P 61 093 SUPERSEDED BY P 23 136

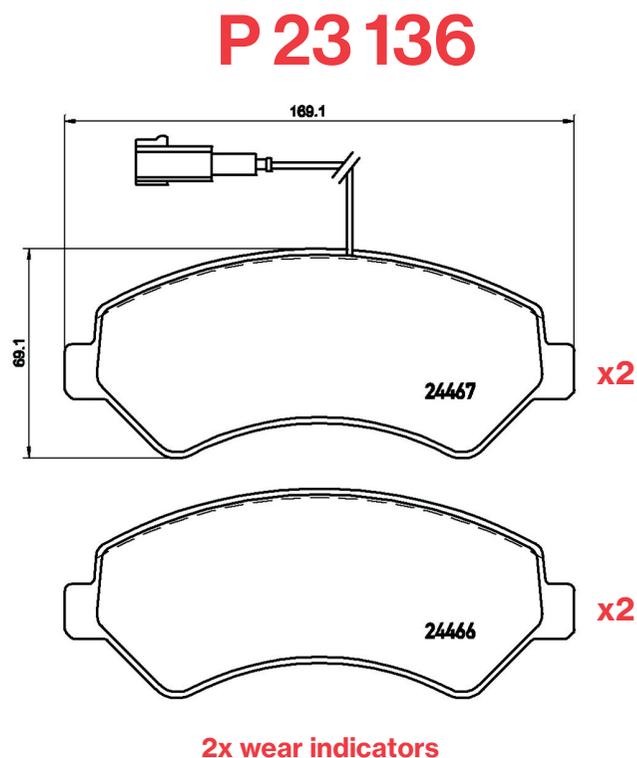
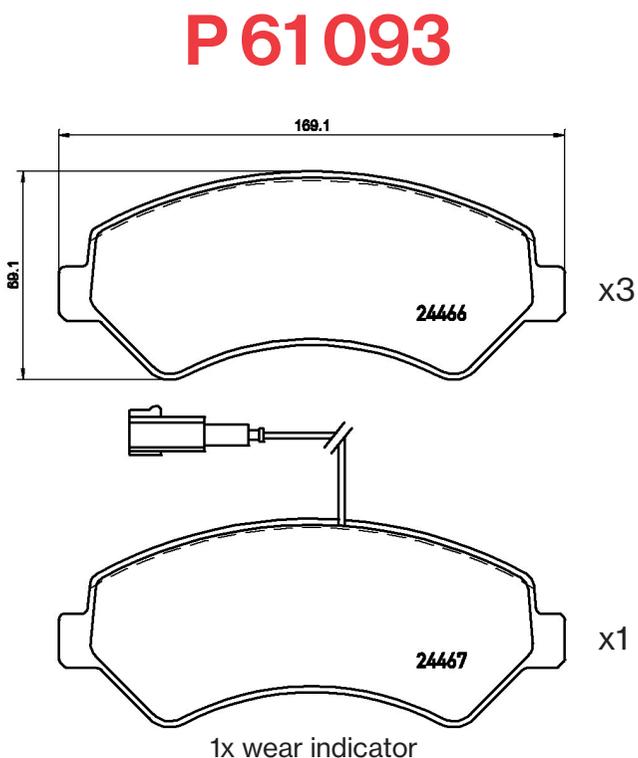
For the references P 61 093, Fiat changed the corresponding OES references from one wear indicator to two wear indicators per set. Wear indicators that are not used have to be simply cut off during assembly. Brembo will perform the same change, according to the OES programme. P 61 093 will be replaced by P 23 136.

Existing stock of P 61 093 can be sold out. Please consider that P 61 093 can be used only on vehicles equipped with one wear indicator.
